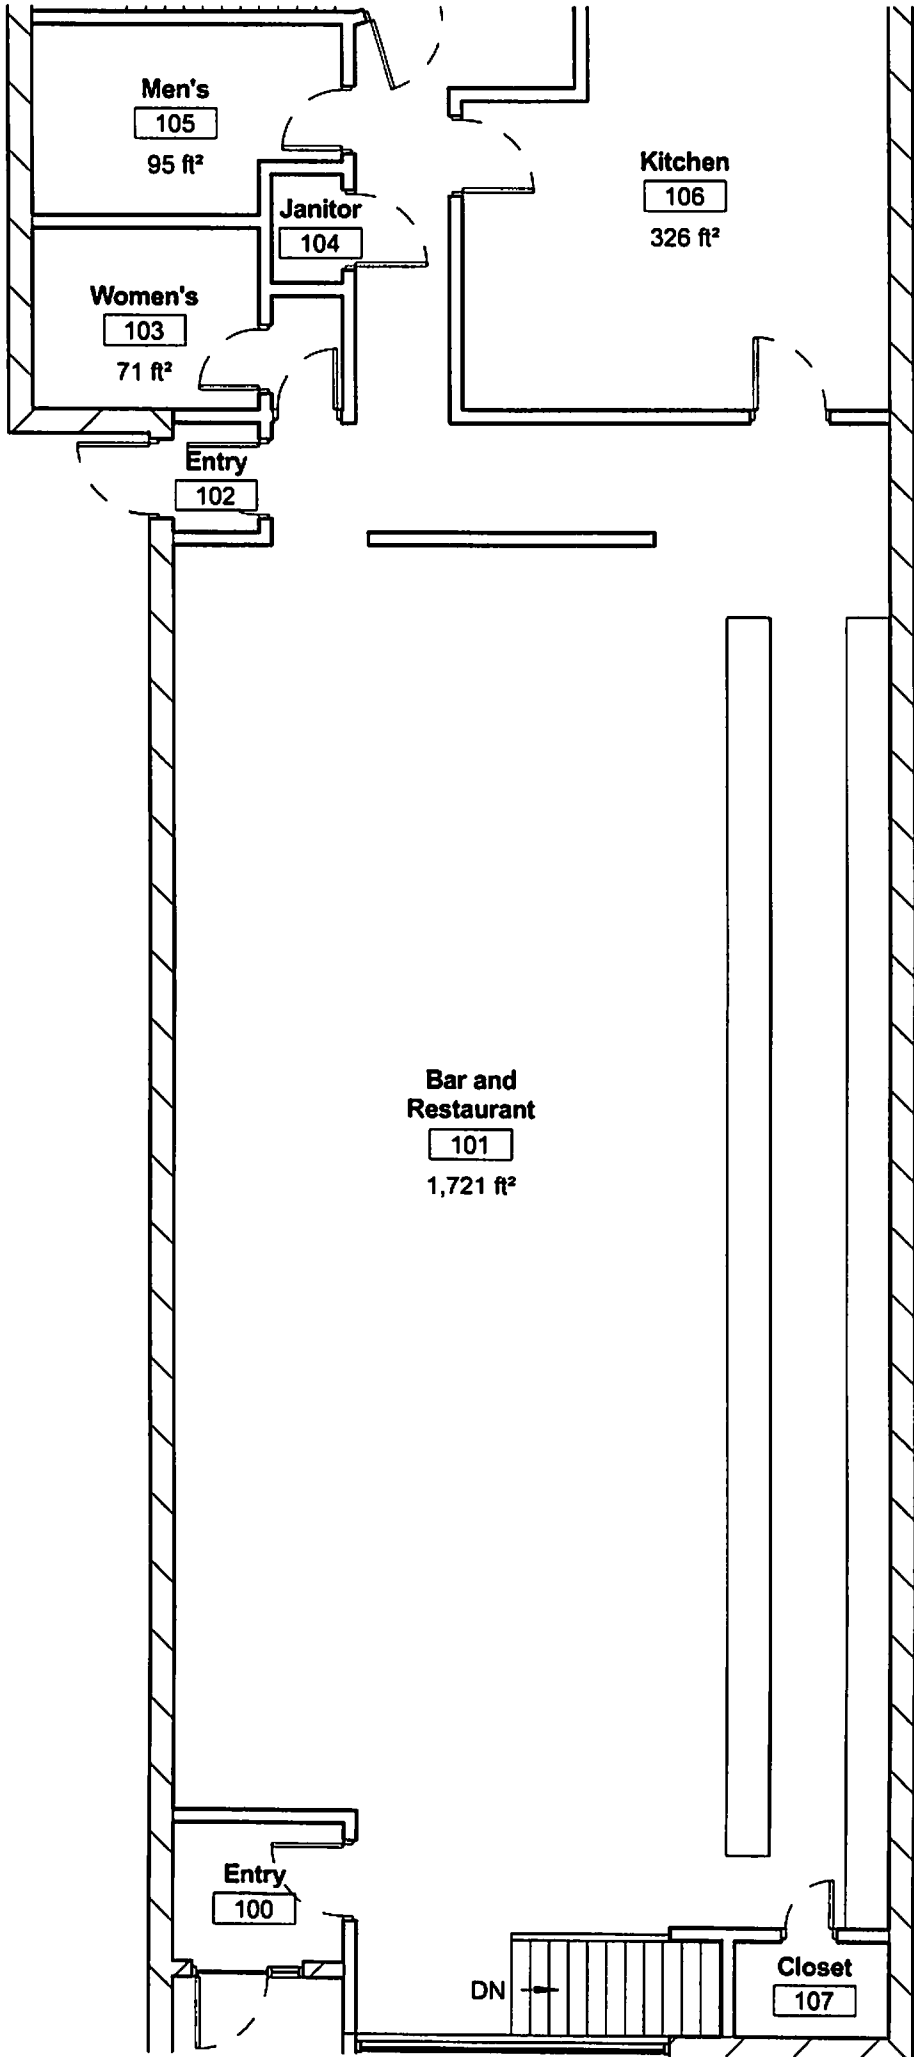
Floor Area Used  
for Sq. Ft. Analysis  
for occupancy

Area to be decreased  
from analysis  
because of  
cabinet installation

• Nardini into architect

• affix tables

Readbolt on doors vs panel
